Department of Energy (DOE) Consolidated Comments

on the Environmental Protection Agency (EPA)

30 November 1994 Preproposal Draft of 40 CFR Part 193,

Environmental Standards for the Management, Storage and Disposal
of Low-Level Radioactive Waste (LLW)

Example Variations in Mean Daily Exposure Rates

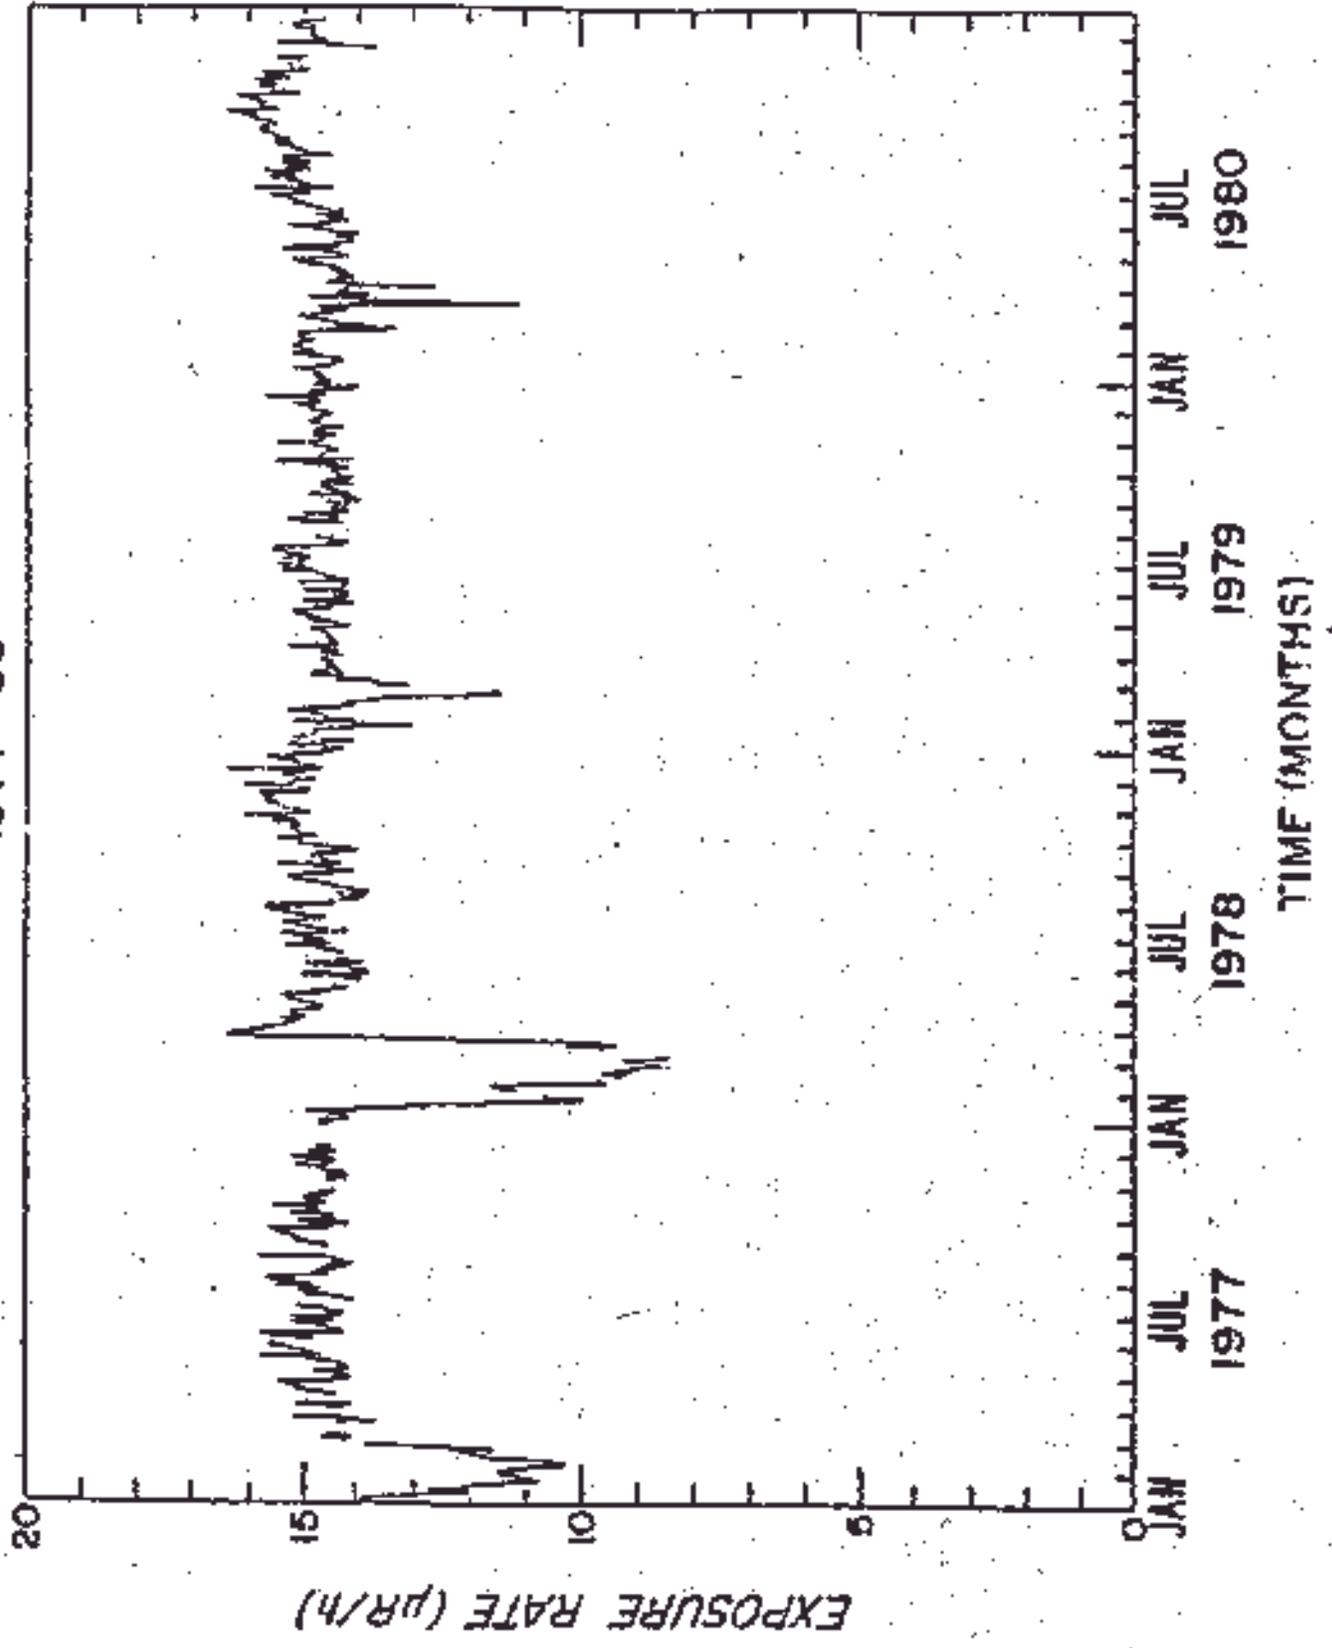
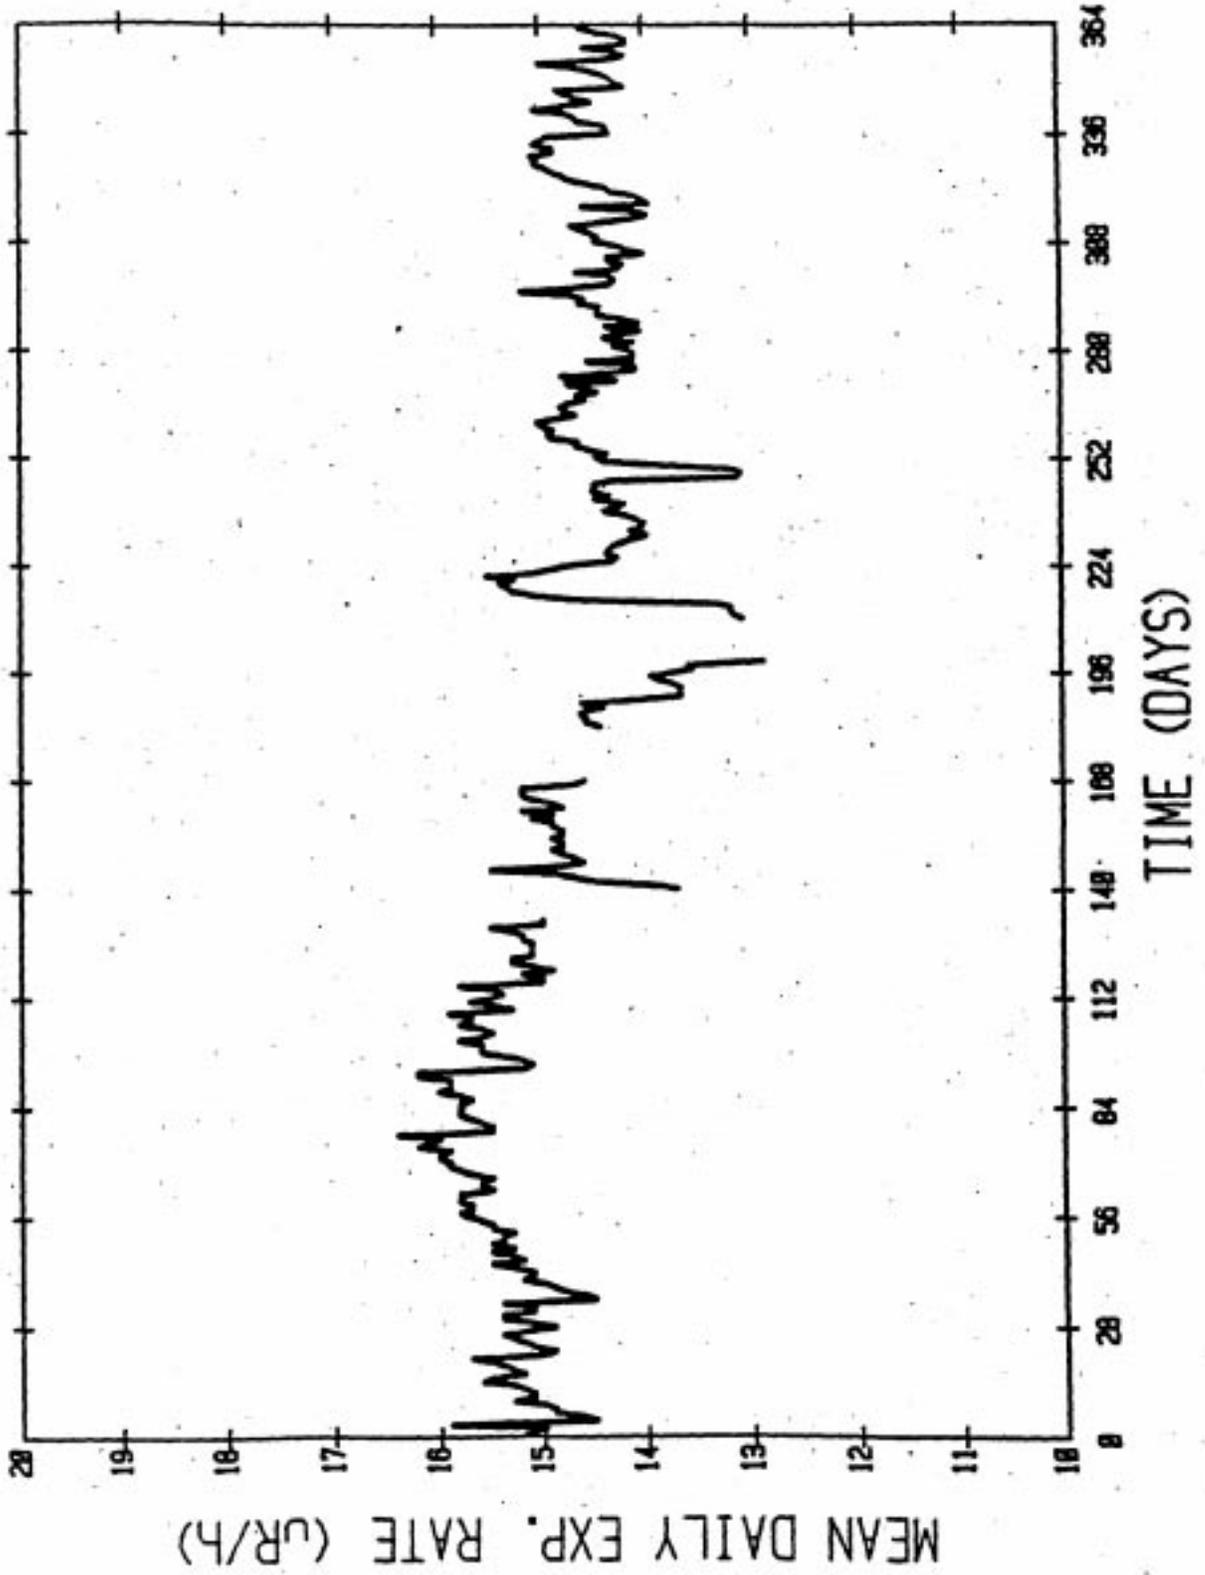
As one problem, an annual 15-mrem standard represents, for direct radiation, a dose rate of only 1.7 microrem per hour (urem/hr). But the natural background dose rate for external radiation is typically 5.8 to 24 urem/hr, and there are hourly, daily, monthly, and seasonal variations.¹¹ Even assuming a low background level of 5.8 urem/hr, a 1.7-urem/hr standard represents only a 30% change. To illustrate the difficulty, we have included (Attachment 5) a pair of graphs that show the variations in hourly dose rates at Chester, New Jersey, as a function of time. The range in hourly dose rate exceeds EPA's standard: For a period between July 1980 and July 1981 the hourly dose rate ranged from about 13 to more than 16 uR/hr. The hourly dose rate ranged from a low of less than 9 uR/hr to a high of more than 16 uR/hr over a period from 1977 to 1980.
